**PROTEST AGAINST RENEWAL OF
NMED DISCHARGE PERMIT #465
MR. STEVE RAEI PERMITTEE
S&R OPEN PIT SEWAGE LAGOON**

**SUBMITTED TO
MR. JASON HERMAN
NEW MEXICO ENVIRONMENT DEPARTMENT
GROUND WATER QUALITY BUREAU
POLLUTION PREVENTION SECTION
1190 ST. FRANCIS DR. SANTA FE NM 87505**

**SUBMITTED BY
THE STAGECOACH NEIGHBORHOOD ASSOCIATION
JOHN DURHAM, BOARD PRESIDENT
PO BOX 368, EL PRADO, NM 87529**

Re: Renewal of DP-465 S&R Septic Service Discharge Permit

Figure 3. The Waste Mgmt well near the site.
 (From Benson, 2004)

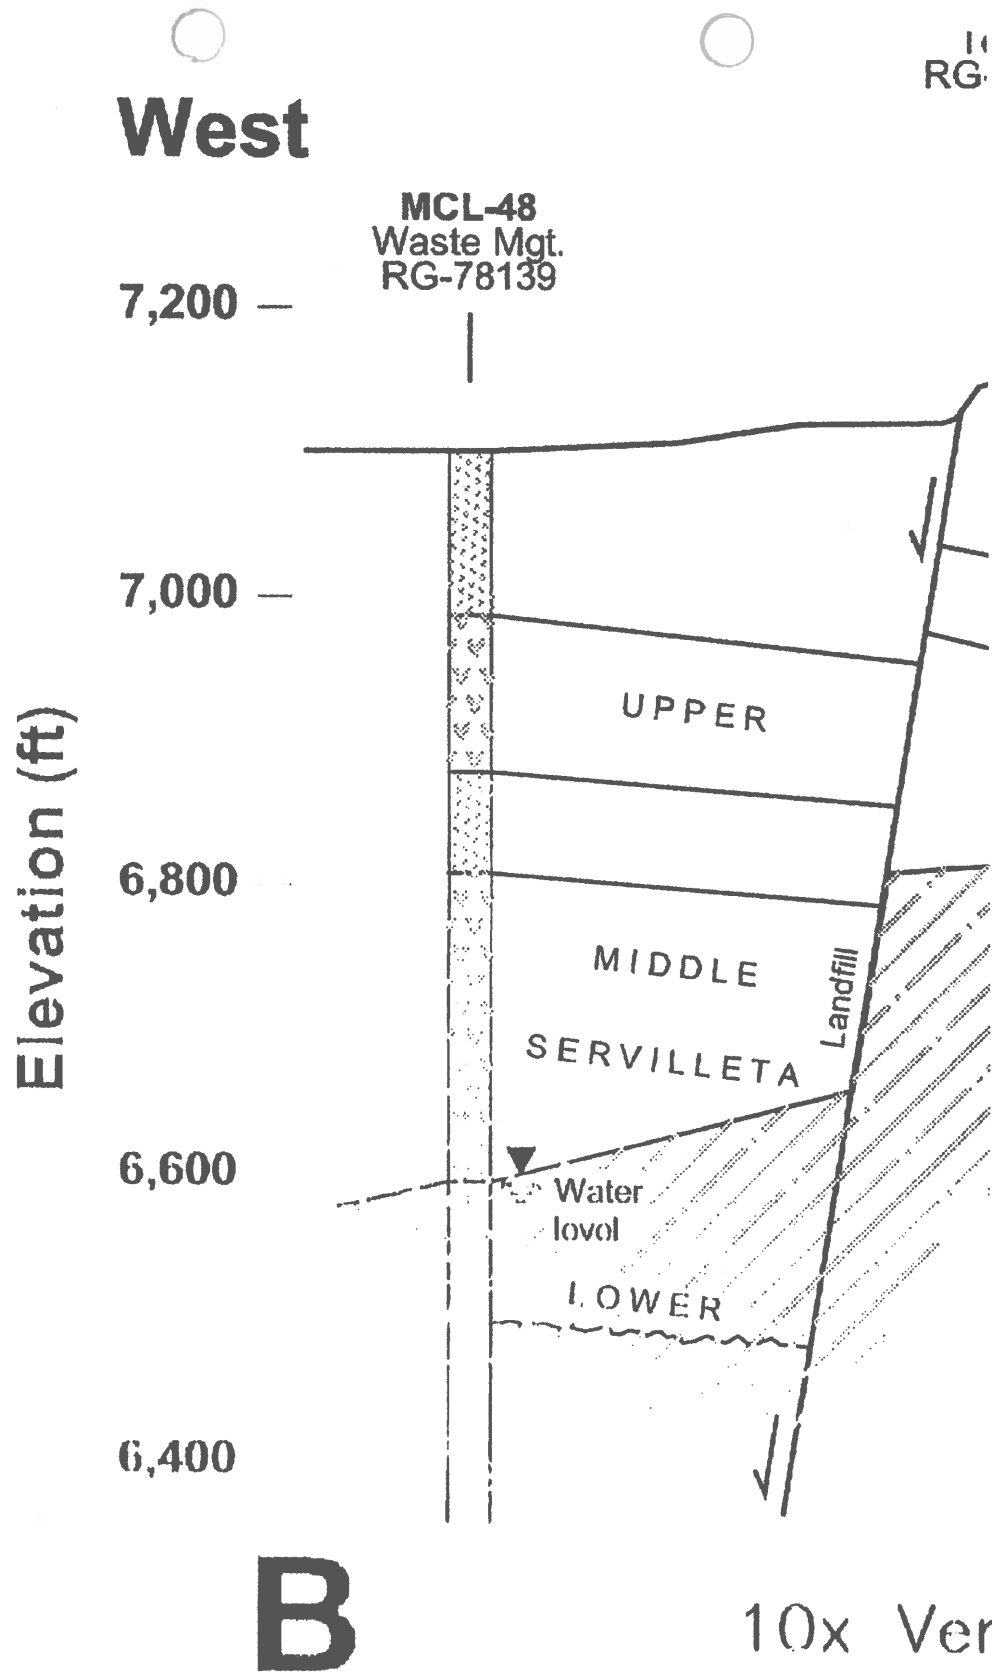
Contamination of the groundwater below the water table may result from nearby water wells. One well, RG-78139, is 1140' from the cells. RG-78139 was drilled with an 8" bit and cased with 5" SCH 40 PVC pipe. The casing was not cemented to the borehole, leaving a 1.5" ring of void space between the borehole wall and the casing. This "annulus" extends vertically from the surface casing to the water table and to the bottom of the well. The annulus was packed with gravel during the well completion, but this gravel pack is not sufficient to isolate the water table from effluent from above. If effluent reaches this borehole, via the alluvium or the basalt, it has essentially an open conduit to the water table below (Figure 6). The only thing that may keep it from entering the annulus is a thin amount of drilling mud cake in the borehole wall. There are no records of either packers or cement in the well. The well should be monitored closely for signs of communication with the lagoons. Although it is 1140' from the south edge of the cells, an effluent plume only needs to move at a rate of 37 feet year to reach this borehole. Thus it is critical to know where the effluent is in the subsurface, and to know where it is moving. If it is moving toward this well, it should be properly plugged by drilling out the PVC casing and gravel pack, setting 5" steel casing, cementing the annulus to the surface and setting cement plugs in the casing.

Figure 4. The 32 year line has been interpolated onto the "fine sediment above coarse sand" chart. Effluent depth is ~ 84'. Fine sediment over gravelly sand would be deeper, maybe 100-110'.

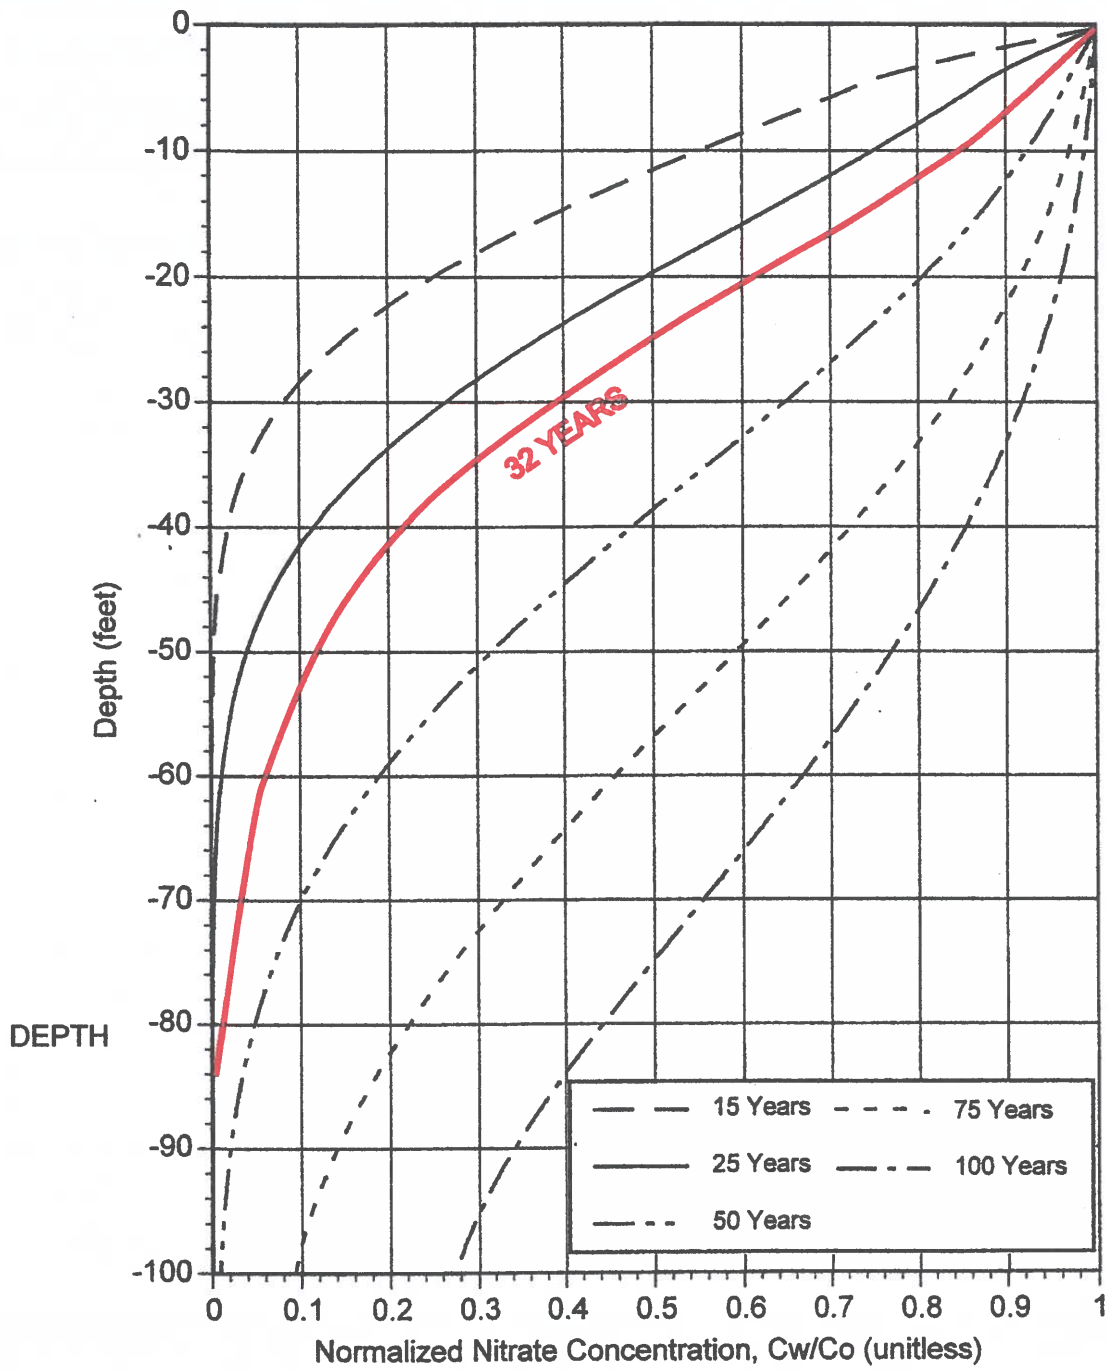
of nitrate over time. I have extracted Figure 17 from this report (Fine grained layer over coarse sand) and have interpolated the 32 year timeline onto this figure (my Figure 4). At 32 years, this model predicts the depth of effluent (i.e. zero nitrates) to be ~84 feet. However, Duke describes the upper 30 feet at the Taos site as "gravelly sand", which is likely to be substantially more permeable than their coarse sand model. Thus it is likely that effluent has penetrated to depths of more than 100, the depth of the Upper Basalt.

Figure 6 A POSSIBLE CONNECTION BETWEEN THE SEPTIC LAGOONS AND THE WATER TABLE

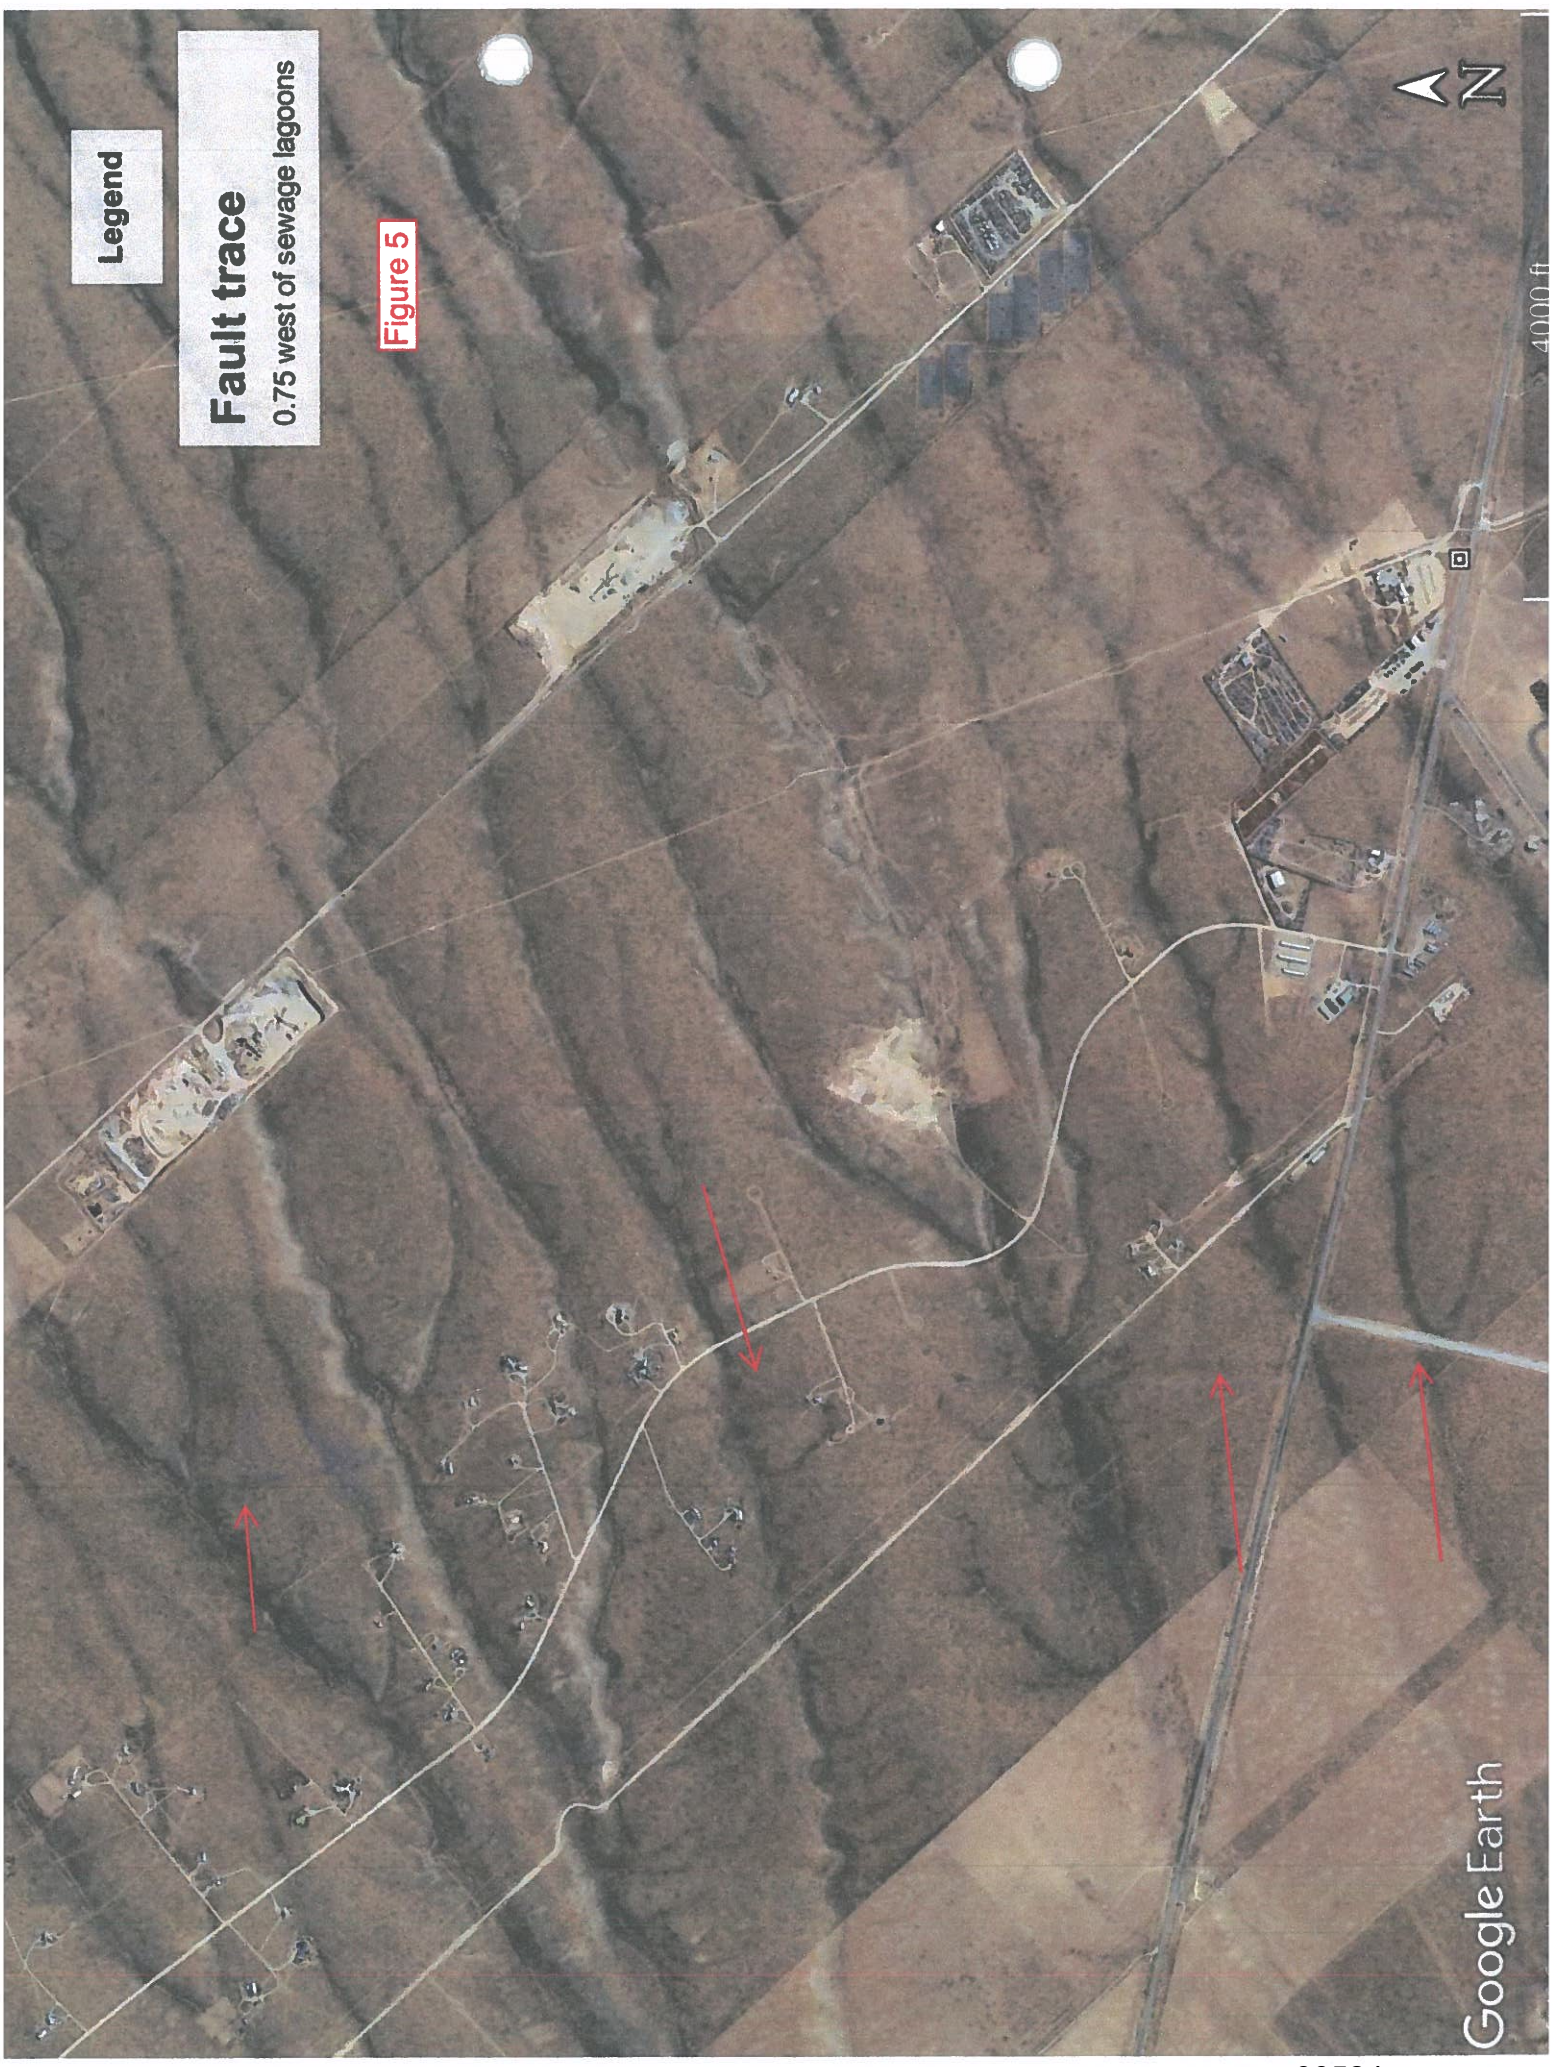
There are faults in the area that have not been mapped or published (A. L. Benson, oral communication, 2018). These north-trending normal faults can be seen on high resolution aeromagnetic surveys conducted recently by the U.S. Geological Survey. These north-trending faults run through the area approximately 0.75 miles east and west of the sewage cells. Open fractures associated with this fault extend through the Servilleta Basalt and would enable effluent from the cells to move rapidly down to the water table. The trace of the western fault can be seen on Google Earth images (Figure 5). The fault zone is permeable: note the darker color of the fault trace (a result of denser vegetation) and increased amount of purple flowers along the trace near the northern red arrow. The water table dips to the west from the cells, and if contamination reaches the water table and hits this fault, it would spread along the plane of the fault, and expand and complicate the plume.

Figure 7. The septic system 7/2018.

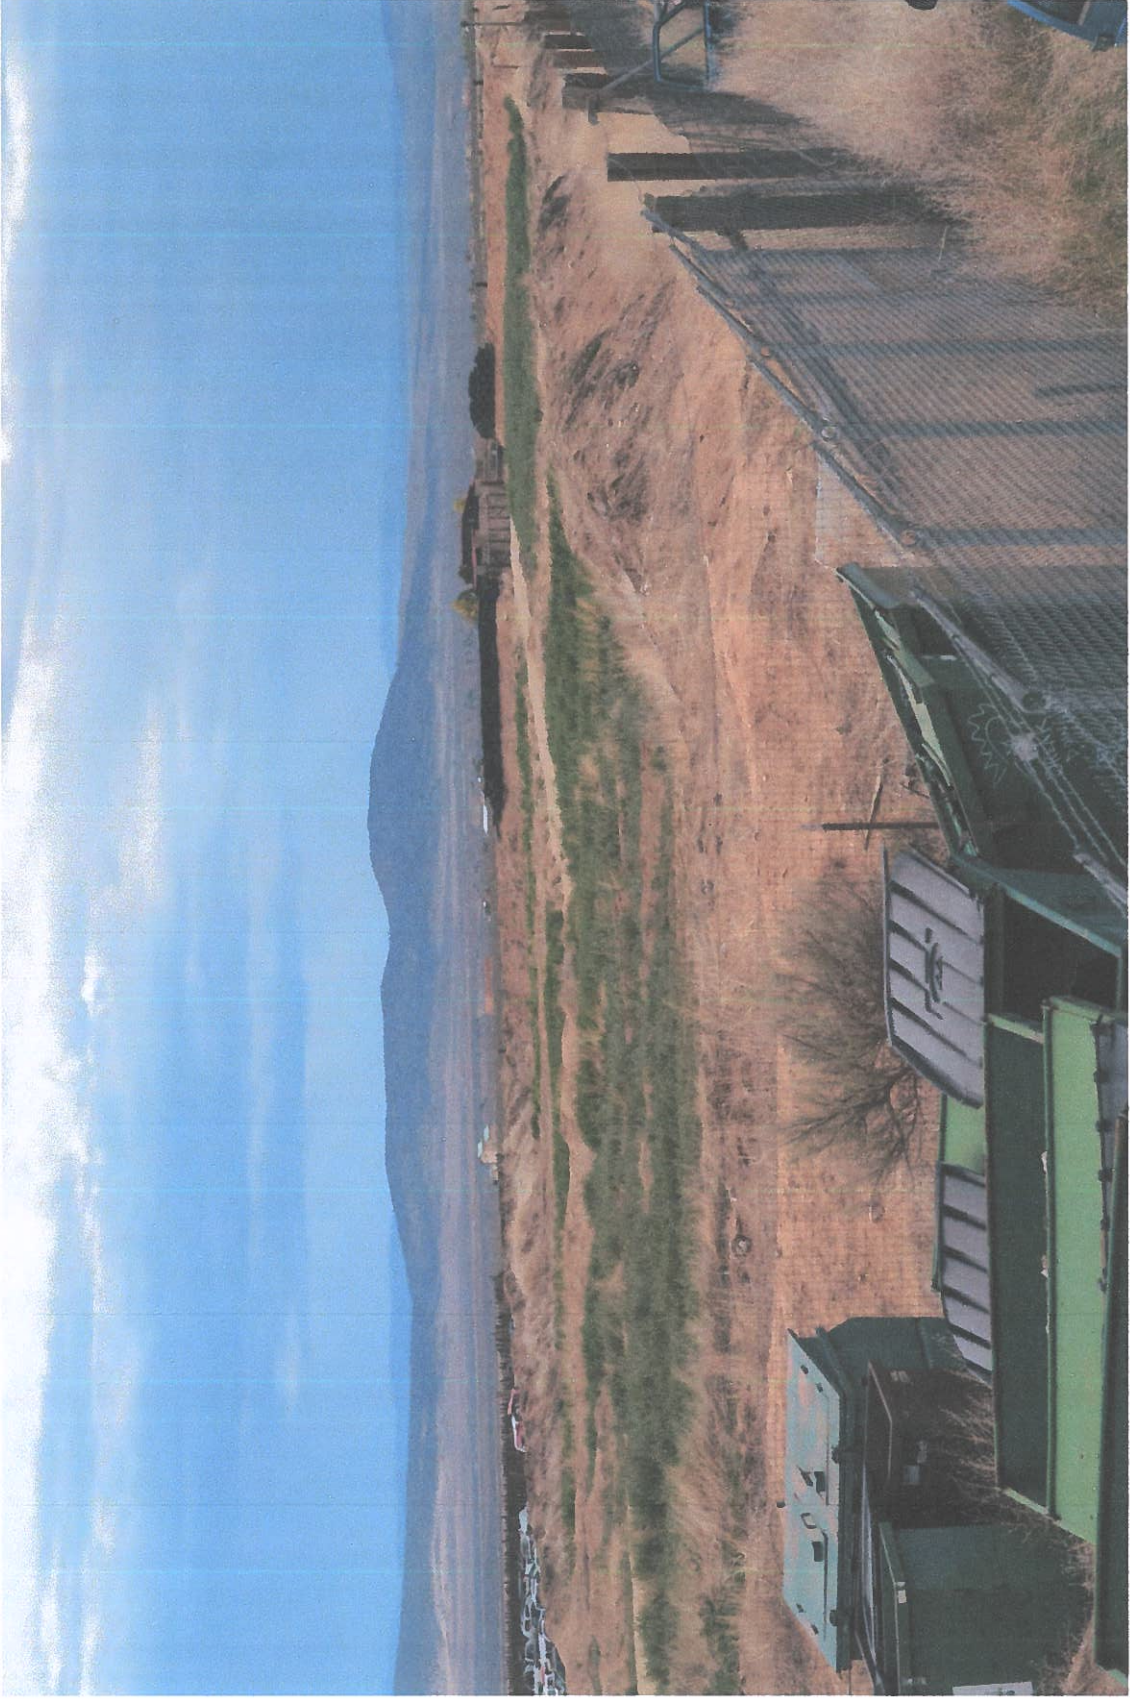
down by microbial action, and the water is clear and free of vegetation. This water is clean and does not pollute the aquifers. In contrast, these cells are choked with verdant, green weeds that indicate that the waste is being converted into fertilizer instead of being consumed by aquatic bacteria (Figure 7). In addition to the odor and flies, the problem is that the pathogens in the waste have not been consumed and are free to leach downward toward the water table.
